REGULAR OPEN MEETING OF THIRD LAGUNA WOODS MUTUAL ARCHITECTURAL AND CONTROL STANDARDS COMMITTEE

**Monday December 27, 2021: 9:30AM - 11:30AM
VIRTUAL/IN PERSON MEETING**

DATE: December 27, 2021
FOR: Architectural Control and Standards Committee
SUBJECT: Variance Request: Mr. Steve Grogan of 5063 Avenida Del Sol (Villa Terraza, Plan C10RC_1) Master Bedroom Extension and Foyer Addition

Existing 3355 A Floor Plan - CASA PALMA

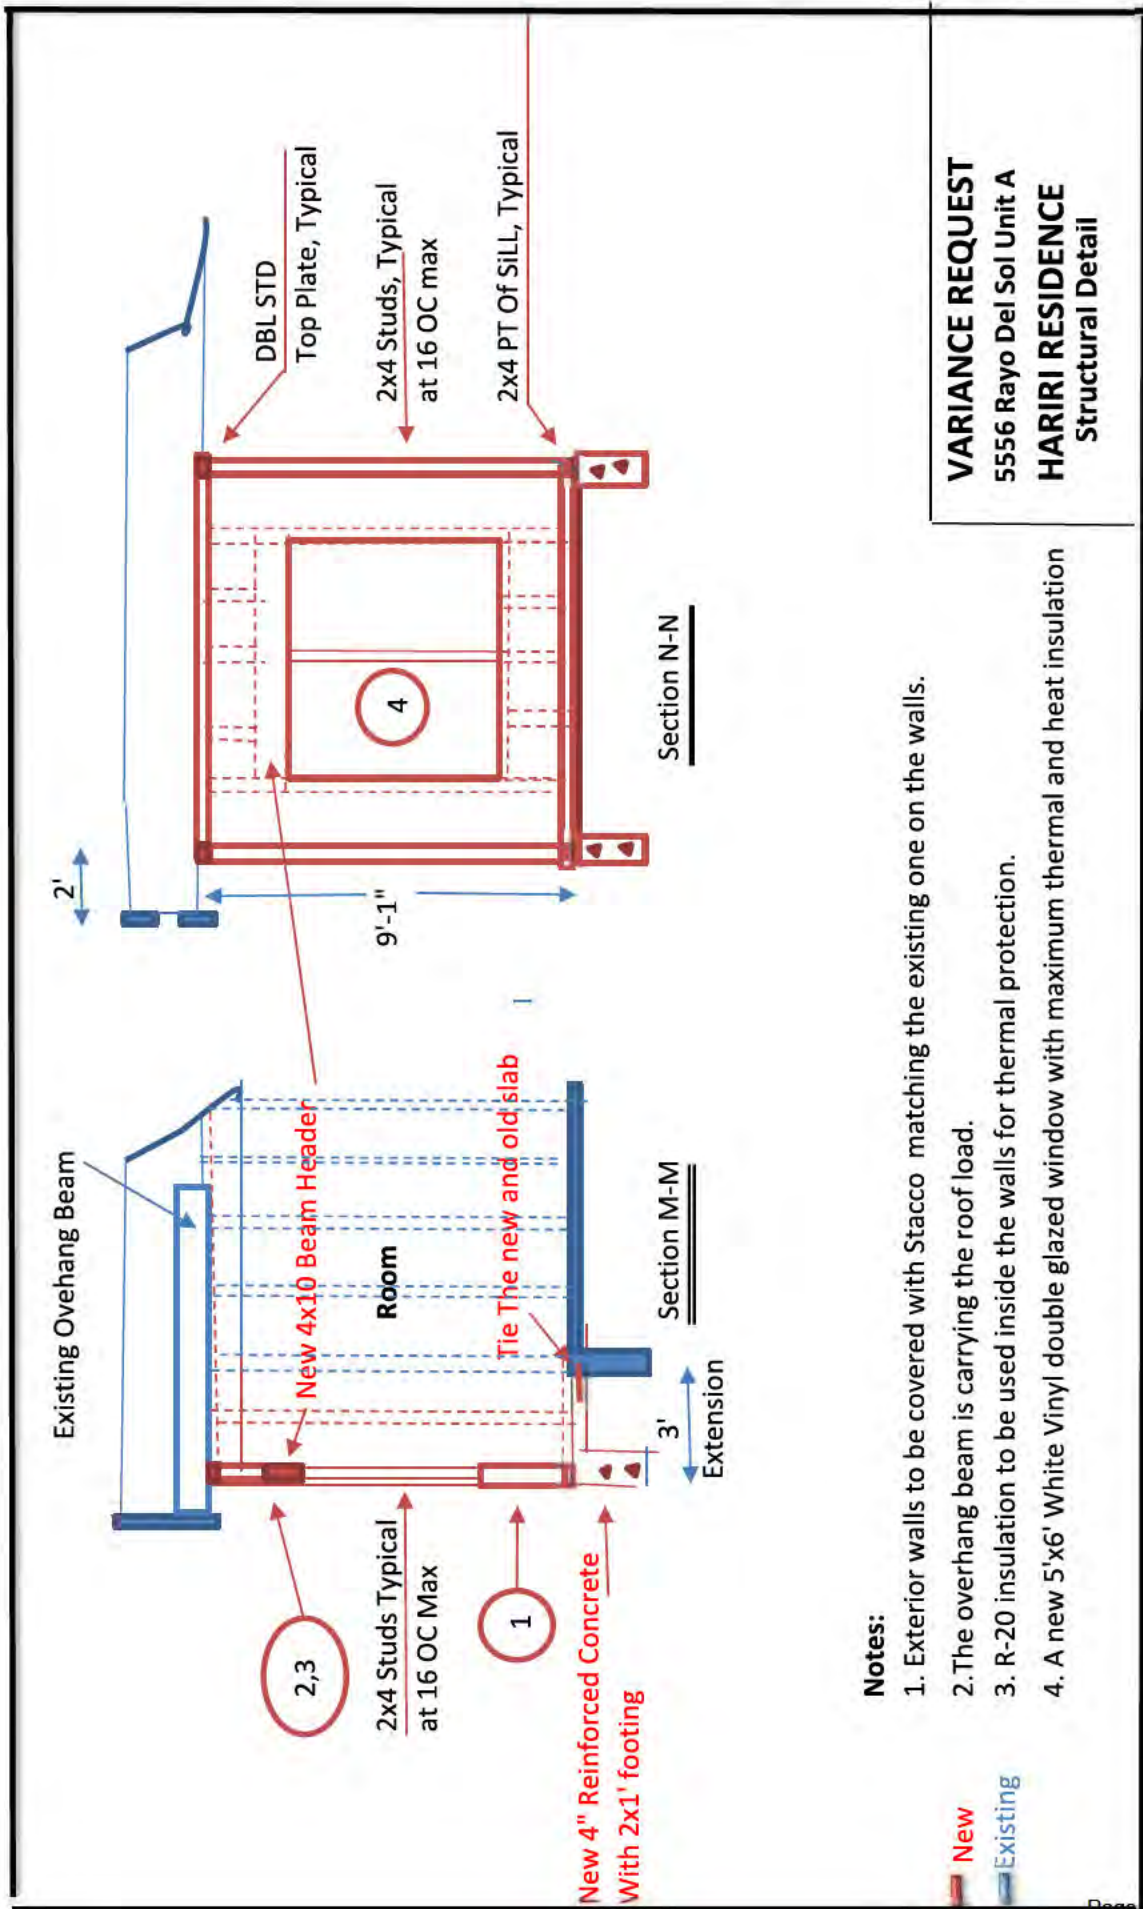
Staff reviewed the submitted documentation and requested architectural drawings for clarification. The resident has indicated that the provided documents are sufficient, and that prior to the approval of the variance, the added expense of providing architectural drawings for a room addition is unwarranted.

- *The submitted proposal for a Variance Request must be **legible, clear and concise and should not require assumptions on the part of the reviewing agent.***
- *The plans must represent a **true replication** of both the existing floor plan and proposed floor plan modifications, scope of work, inclusive of specific dimensional details of each. The plans must identify the precise location of the proposed alteration and any related alterations/installations. For example, if the proposal is for a room expansion, the re- location of doors, if necessary, should be identified.*

The elevations and plans do not accurately reflect the architectural conditions. The description of the new walls not carrying any load, the amount of insulation to be contained within the walls, as well as the overall appearance of the drawings are inaccurate. Without properly drafted architectural plans, it is difficult to determine the extent of the finishes, volumes, profiles, and other construction components of the project.

Attachment One (continued) – Standard 32 Water Heater Relocation with Redlined Comments

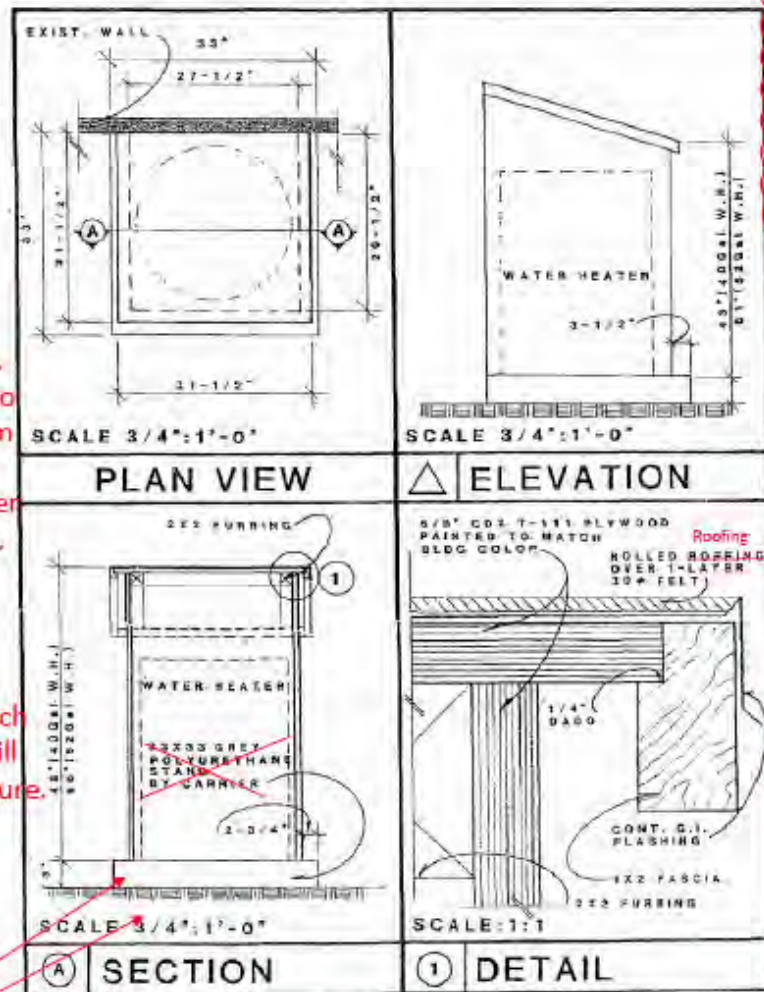
No reference to if the enclosure is to be locked and who is allowed access.

Details do not show access door, hardware, or conc. pad alternative. this should be provided w/ dtl.

Attachment Two (continued) - Request for Design Consulting Services Standard 32 Revision

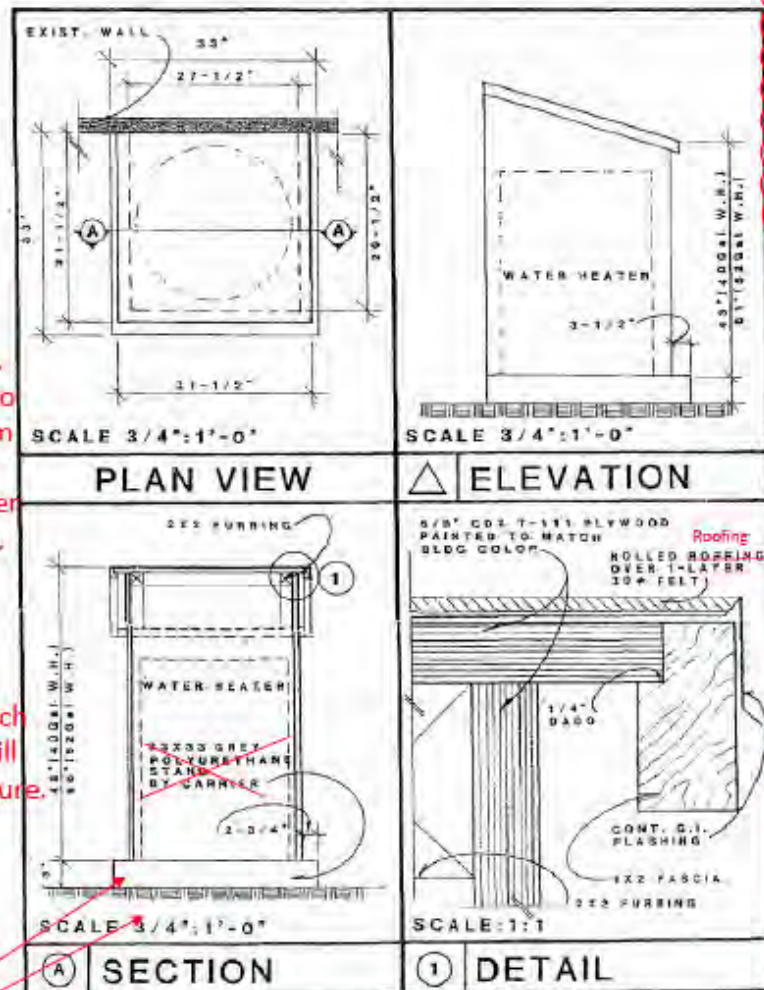
No reference to if the enclosure is to be locked and who is allowed access.

Details do not show access door, hardware, or conc. pad alternative. this should be provided w/ dtl.

Attachment Three (continued) – Request for Construction Estimate of Standard 32 Revision

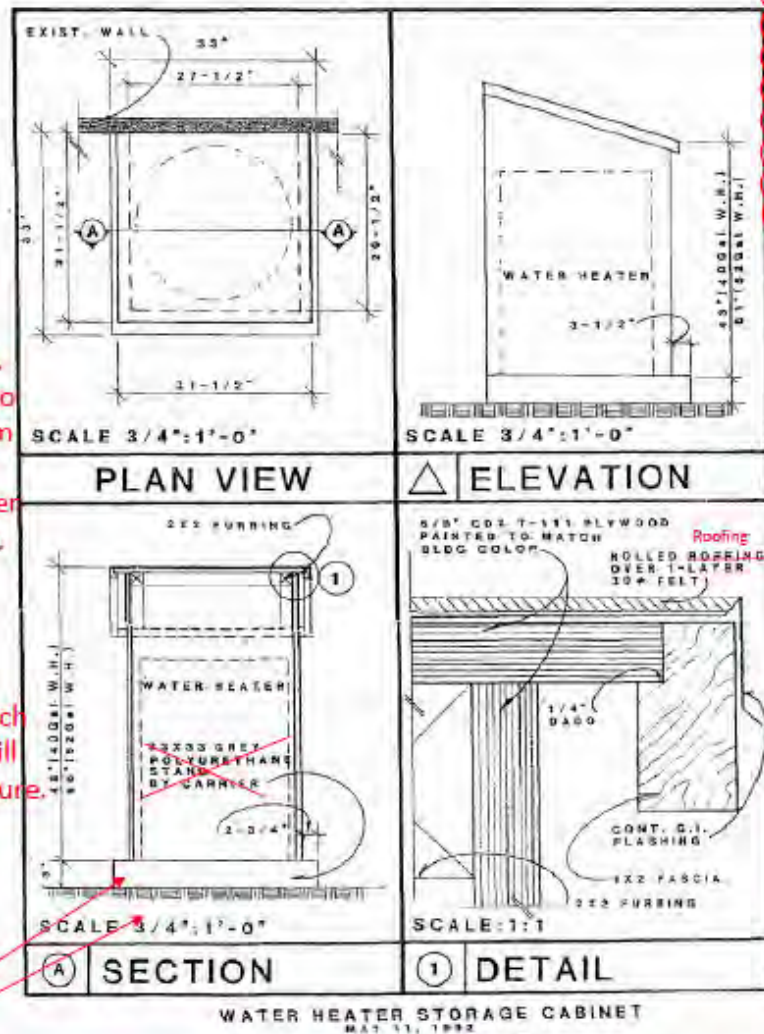
No reference to if the enclosure is to be locked and who is allowed access.

Details do not show access door, hardware, or conc. pad alternative. this should be provided w/ dtl.
